Detailed Planned Development

For the development, known as Admiral's Wharf located at 234 South Water Street

Water Review Comments for Admirals Warf, 234 S. Water St.:

**CURB AND SIDEWALK RAMP TYPE II
WITH PEDESTRIAN CURB**

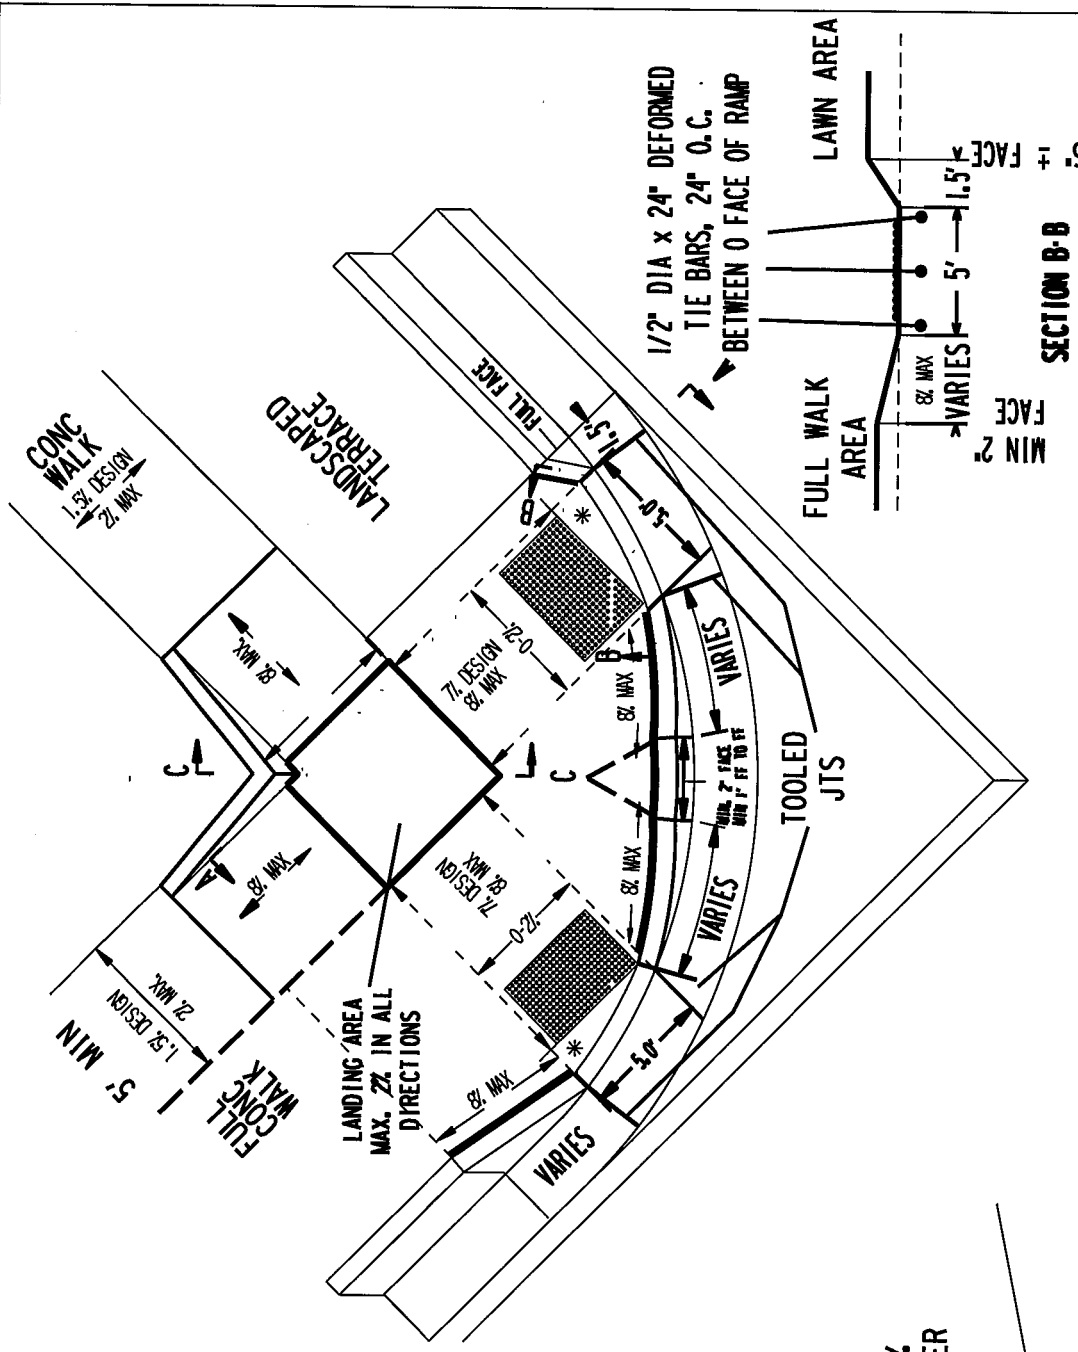
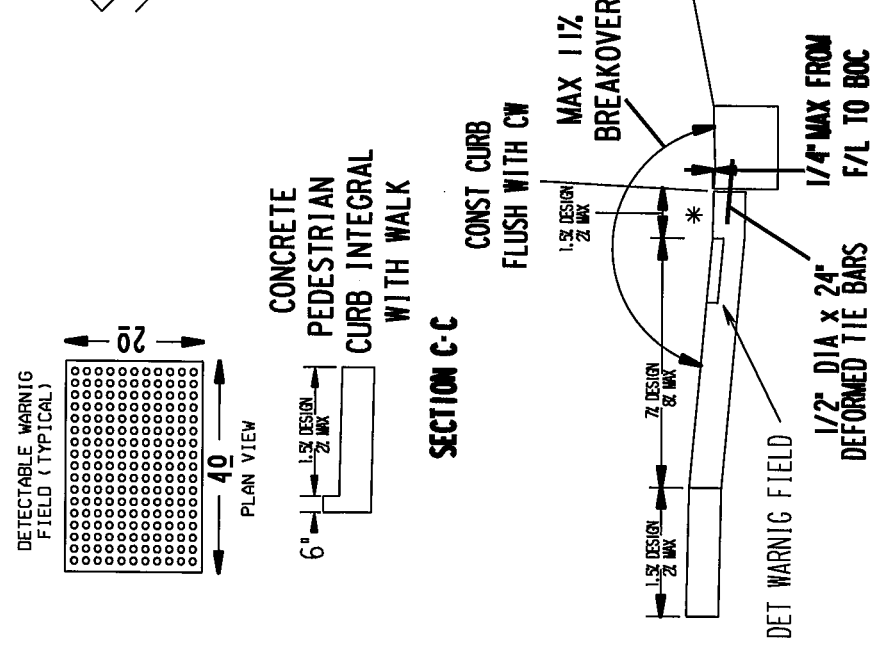
2. Must use the most up-to-date detail for the Type 2 pedestrian ramps. See attached. Provide detail showing ramp grades (bottom of ramp, top of ramp, flares, landing area, etc.) All grades must be ADA compliant. The landing area for the ramp must be a minimum 4' x 4' IN THE PUBLIC RIGHT-OF-WAY. Based on the layout and design shown, there is not enough space for the landing area.

- Due to the project's location, bicycle parking should exceed the required minimums.
- Install Type II curb ramps on the southwest corner of the property at Pittsburgh and Water by tightening the corner radii and extending the curb along the Pittsburgh frontage.
- Extend the curb on the Pittsburgh frontage to match with the existing curvature of the street

CONCRETE DRIVEWAY TYPE II
(MODIFIED DEPRESSED)

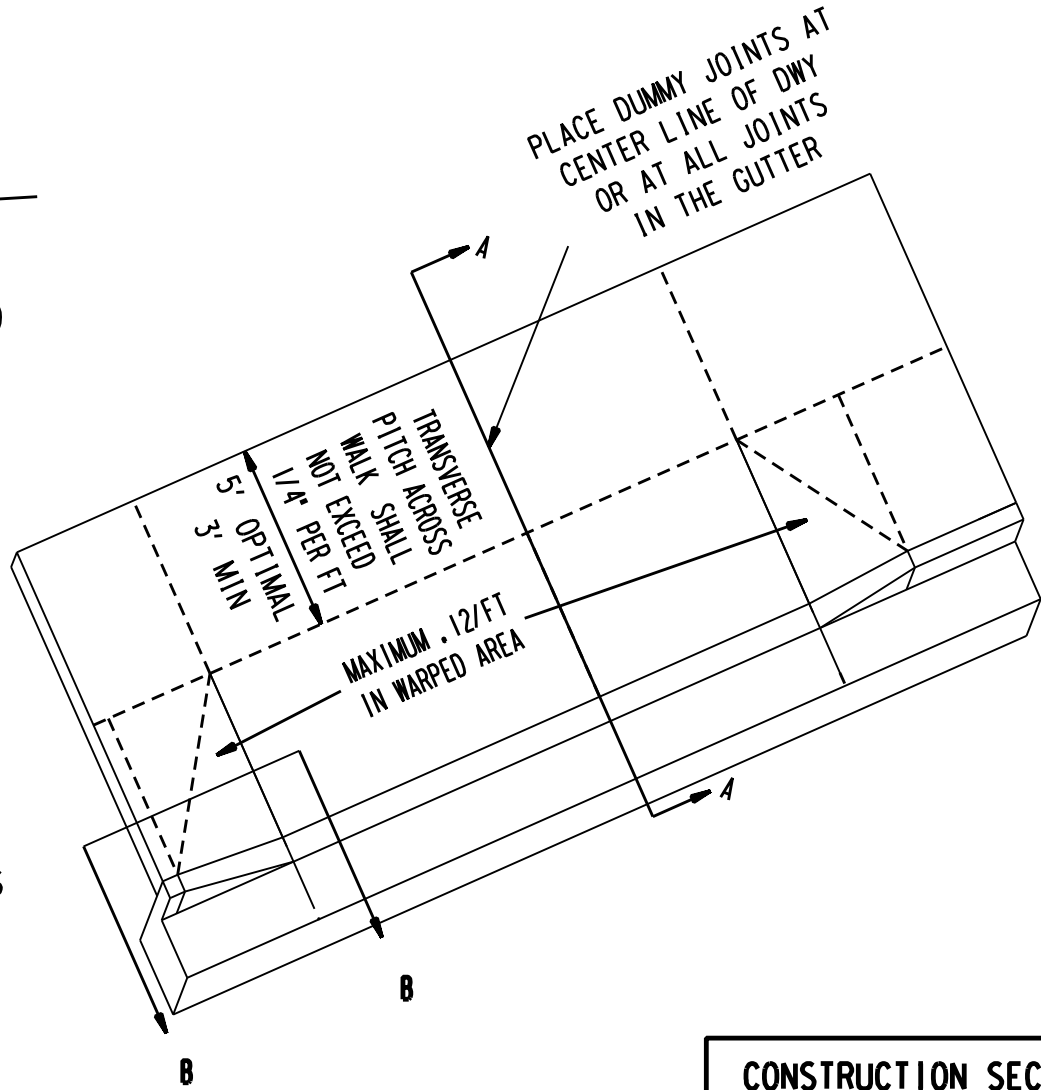
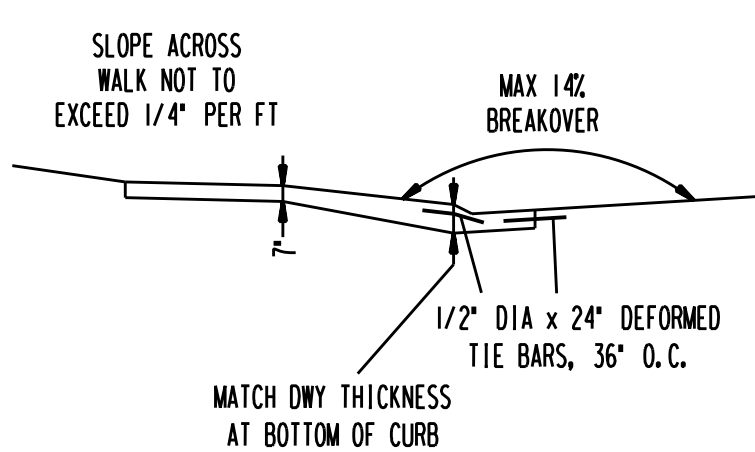
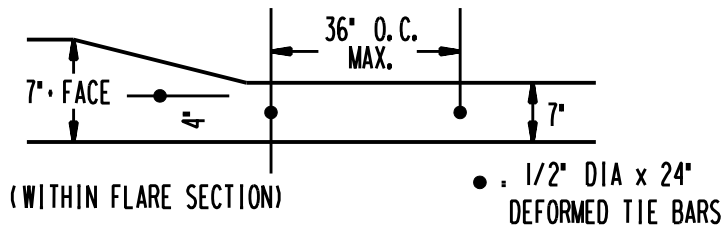
3. Curb returns for driveway approaches are not permitted. A standard city driveway approach must be constructed to serve the parking entrance. Construct depressed driveway and remove the proposed pedestrian ramps on either side. See attached depressed driveway detail.
